Developer Services
Southern Water
Sparrowgrove House
Sparrowgrove
Otterbourne
Hampshire
SO21 2SW

Your Ref
WA/102/18/HH
Our Ref
PLAN-025796
Date
28/12/2018

Proposal: Proposed first floor rear extension and detached single garage.
Site: Holly Tree Cottage, The Street, Walberton, BN18 0PH.
WA/102/18/HH

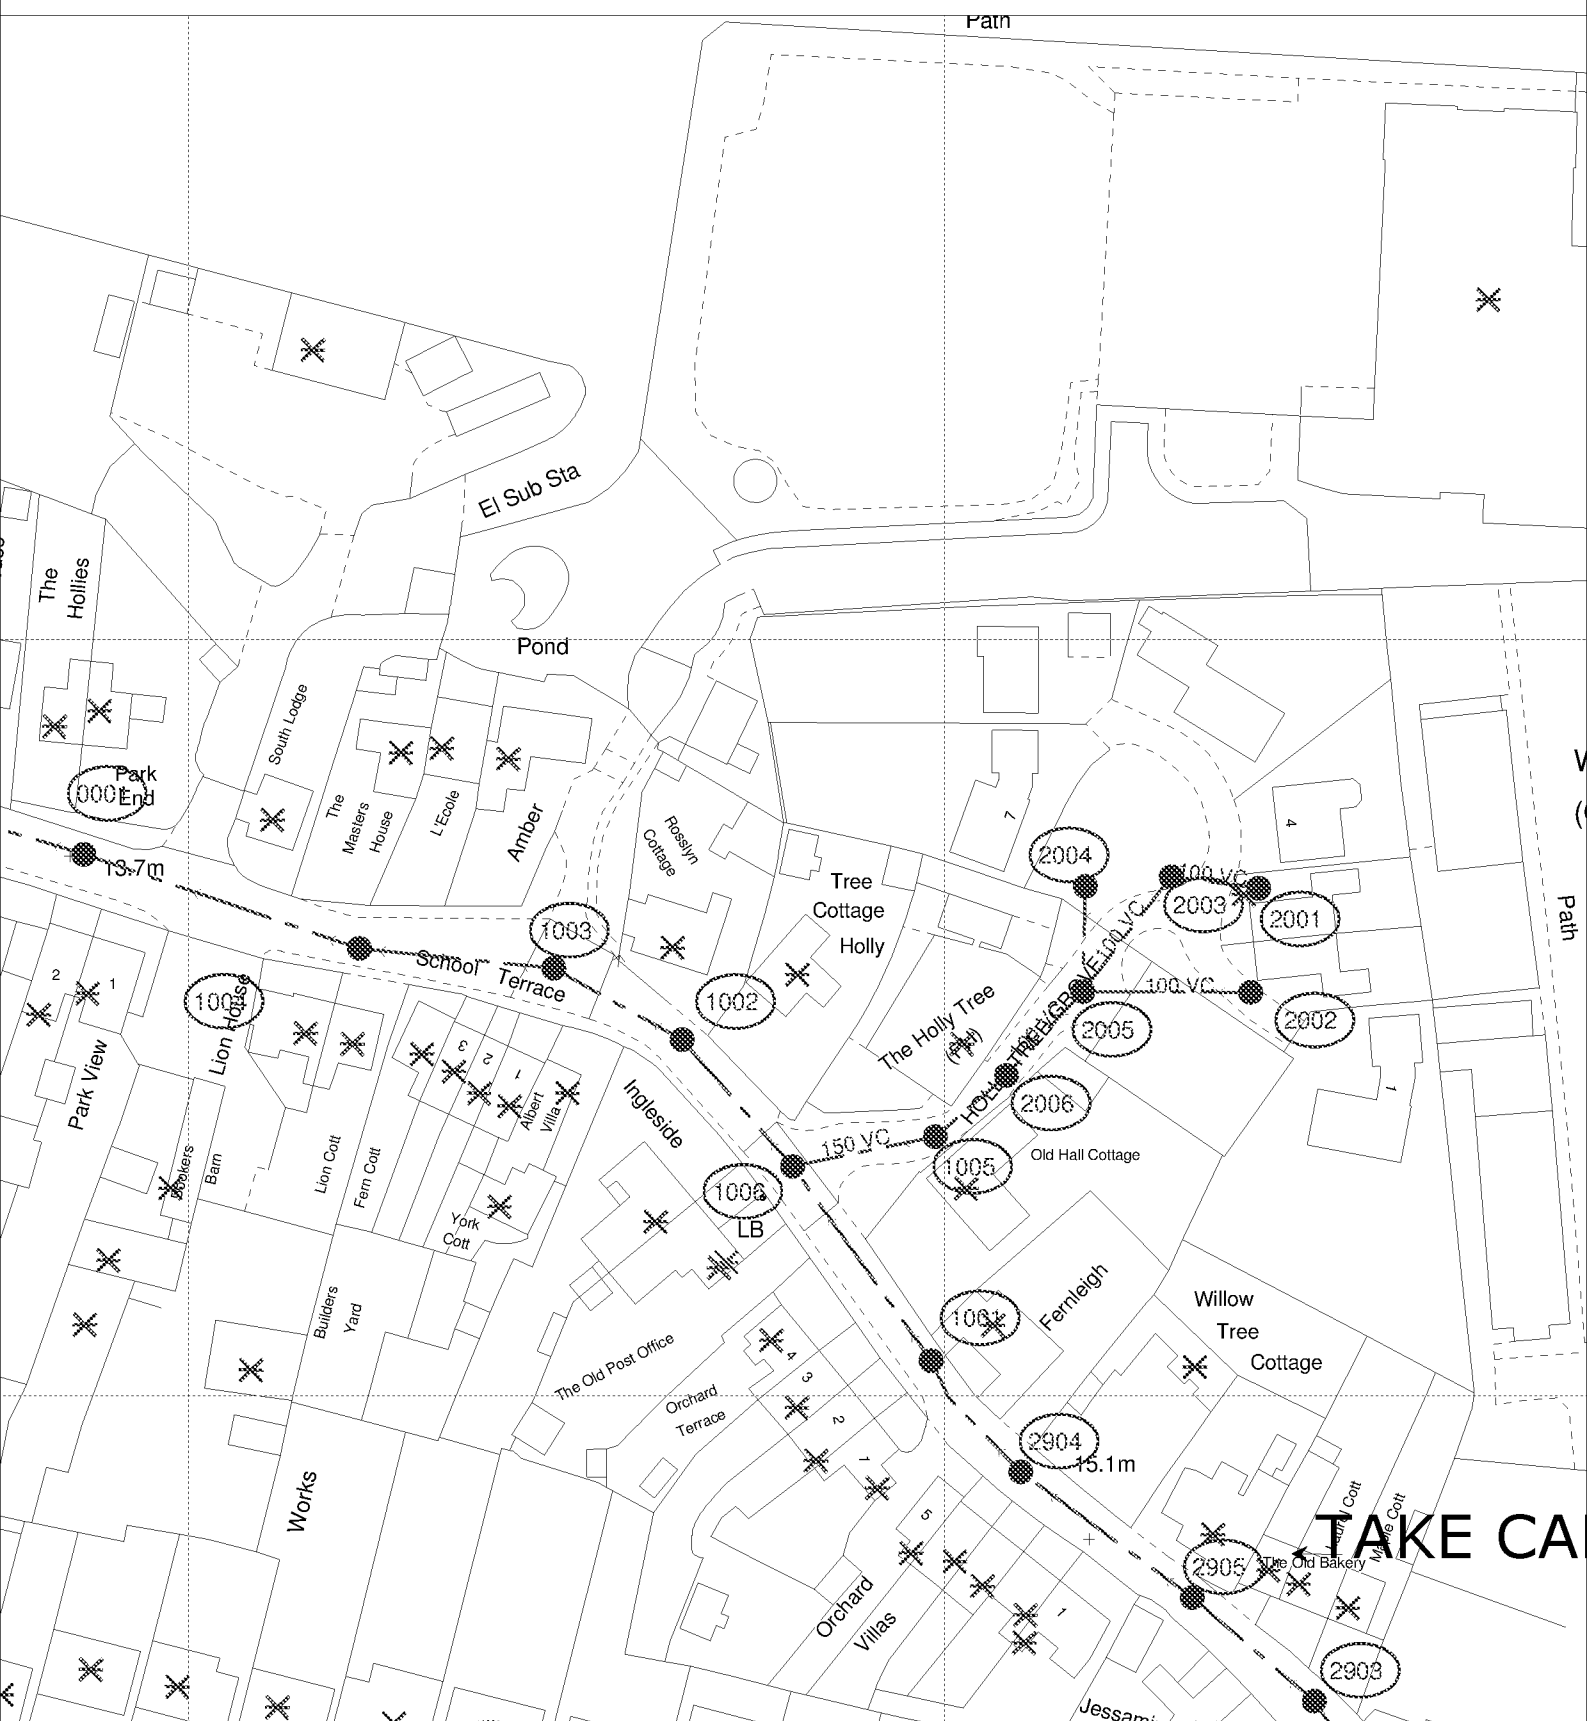
Due to surface water inundation issues in the Lidsey Catchment "The applicant is advised to adopt, where appropriate, the measures in the table "Practical measures to reduce the potential impacts of development".

Developer should look to protect the public sewerage system from inundation and infiltration, which contribute to flooding in unfavourable conditions.
